UNIVERSITY OF  
**SOUTHERN MAINE**  
Facilities Management

Re:                  University Commons,       ☒ Drawings       ☐ Copy of Letter   ☐ Specifications  
                      The Wishcamper Center   ☐ Samples       ☐ Shop Drawing   ☐ Change Order  
                      CBL: 114-D-023           ☒ Other: Copy of Email

Based on discussion of the sketches sent on March 29, we are sending you revised drawings that show our preferred approach for bringing the Wishcamper Center's two story spaces into compliance with NFPA 101. As revised, the location of the overhead coiling 1 hr. rated fire shutter in the First Floor Central Corridor has been shifted, as shown in the attached sketches SKA-011 R1 and SKA-012 R1, to limit the dead-end distance in the North Corridor to 50 feet. A second means of egress from Lobby 108 is to be provided through the Multipurpose Room, by providing that the Multipurpose Room doors at Vestibule 104 are not lockable.

Re: University Commons, University of Southern Maine  
Major Site Plan Review – Additional Information

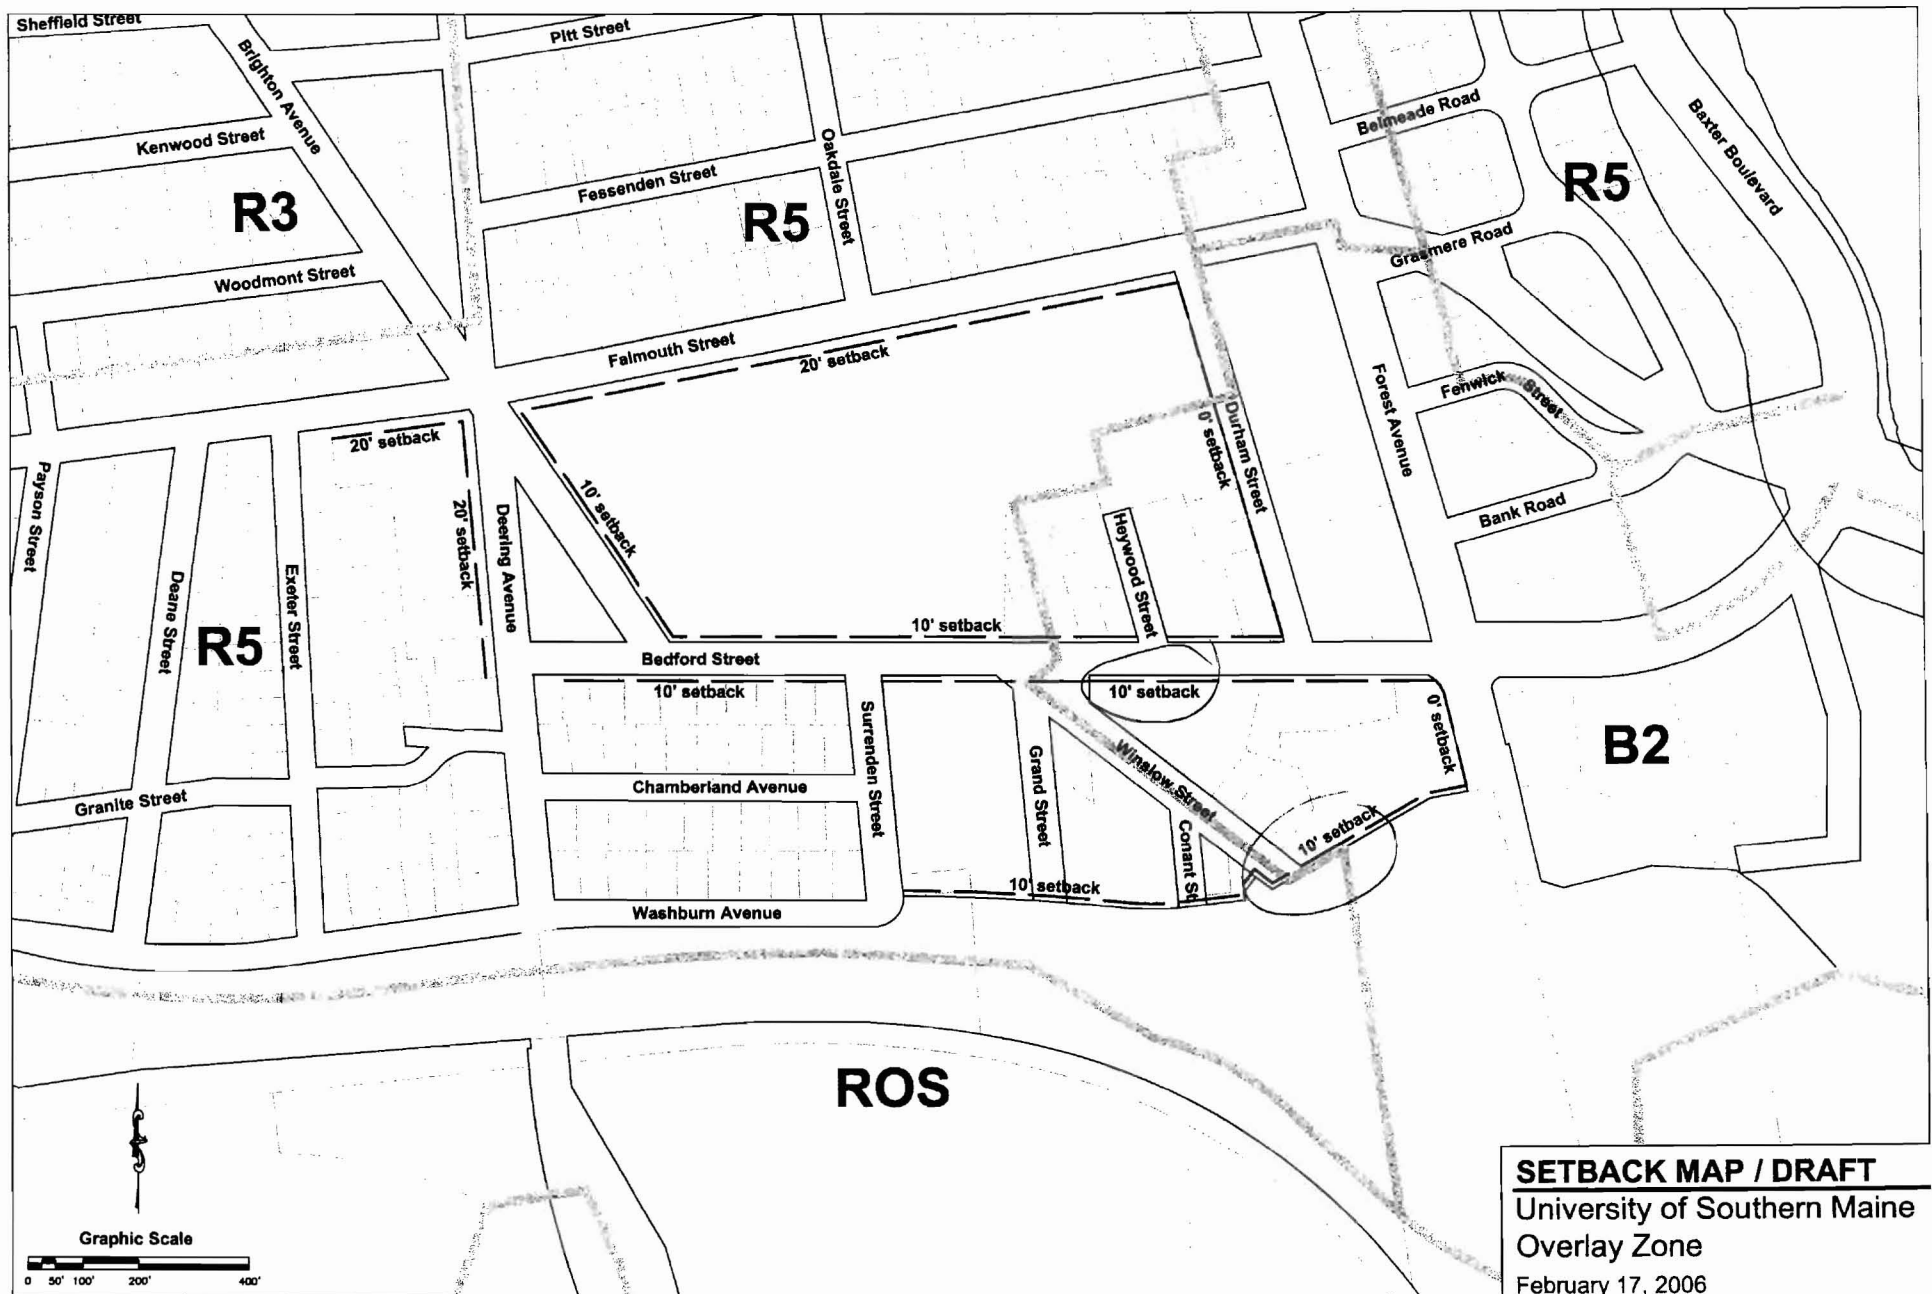
As I mentioned in my voice mail to you, I can not find a site plan submittal for this project. There is a site plan for the existing site prior to demo, but not for the proposed. The applicant also did not provide a zoning analysis.

I am curious. They are proposing "porous pavement". How was that use toward the impervious surface requirements?

Response: Sheet C-201A Proposed Site Plan has been created to assist in identifying the project's conformance with applicable zoning requirements and with the USM Campus Design Principles and Standards. The sheet has been attached to this submittal.

Response: The Zoning Analysis has been included on Sheet C-201A Proposed Site Plan, attached to this submittal.

Response: The zoning analysis included on sheet C-201A presents the post-development impervious area under two different methods. In one, the porous pavement was considered to be impervious surface; in the other, it was not. The proposed project meets the zoning requirements in either case. We suggest the City consider porous pavement as pervious surface in an effort to encourage the use of low impact development techniques within the City; porous pavement is pervious by design.
